CENTERVILLE CITY PLANNING COMMISSION AGENDA

Short Title: Administrative Decision - Public Hearing - Small Subdivision

Small Subdivision Waiver/Lot Split application review for property located at 470 East 400 South, previously reviewed in March 2020.

Short Title: Legislative Decision - Public Hearing - JFCapital - PDO/Conceptual Site Plan Zone Map Amendment for Lots 2 and 3

APPLICATION: **CONCEPTUAL SUBDIVISION WITH SMALL**
SUBDIVISION WAIVER REQUEST

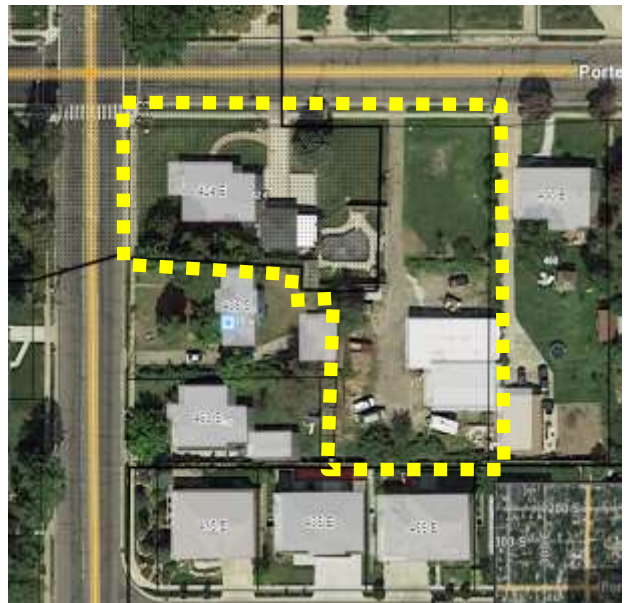
Lot Side Lines/Right Angles (CMC 15.05.020d) – The subdivision plan depicts two (2) lots. The side lot lines towards the rear yards areas jog and are not at right angles, as preferred by the ordinance.

Staff Response: Due to the historical built layout of the site, the general configuration of the subdivision is fixed at this point. The offset property lines were created to accommodate the way the parcel was developed (e.g. home, pool, and garage).

To accommodate these types of situations, the subdivision ordinance does allow some lot line variations, upon receiving a recommendation from the Planning Commission (see CMC 15.05.020, [Lots](#)).

SITE PLAN

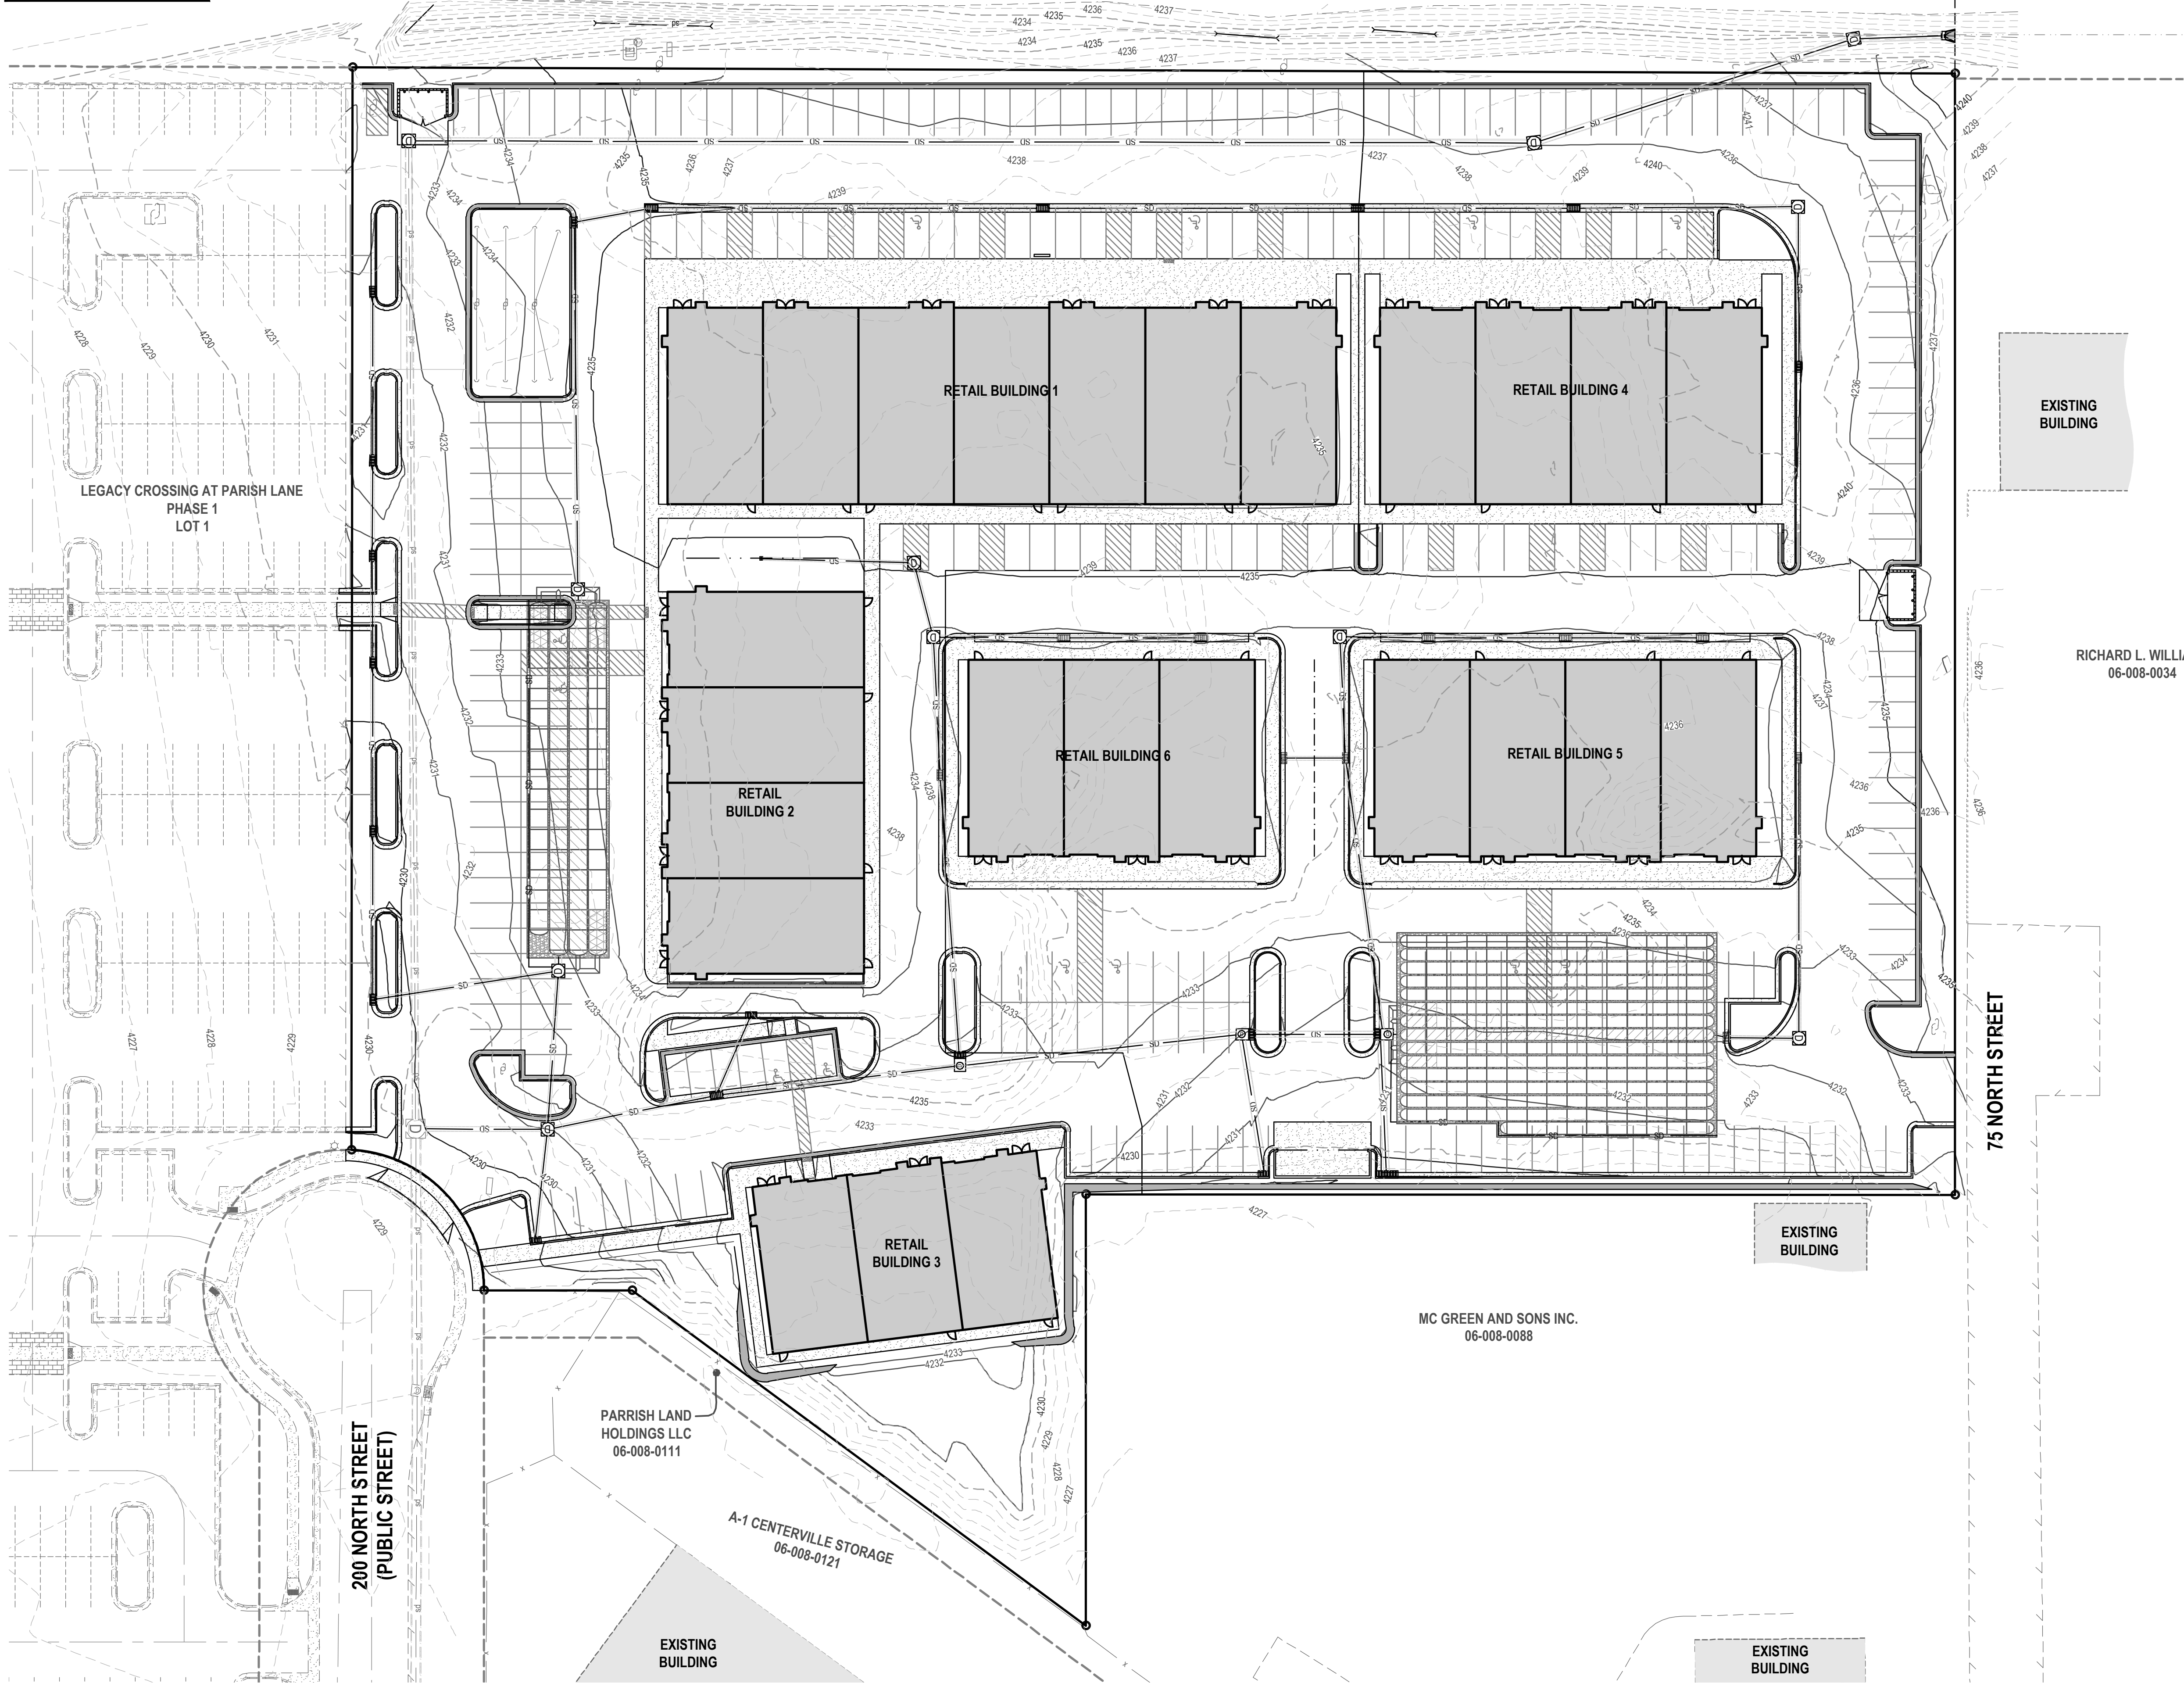
STAFF COMMENT: During a previous Planning Commission review of this similar site layout, the proposed retail building design appeared to satisfy the existing design expectations. This assumption remains the same from a staff perspective.

STAFF COMMENT: After staff’s review of the study data provided, it appears that developing Lot 2 and 3 will provide a minimum required amount of 235 Parking Stalls and allow 67 additional stalls for use by the entire PDO master planned area.
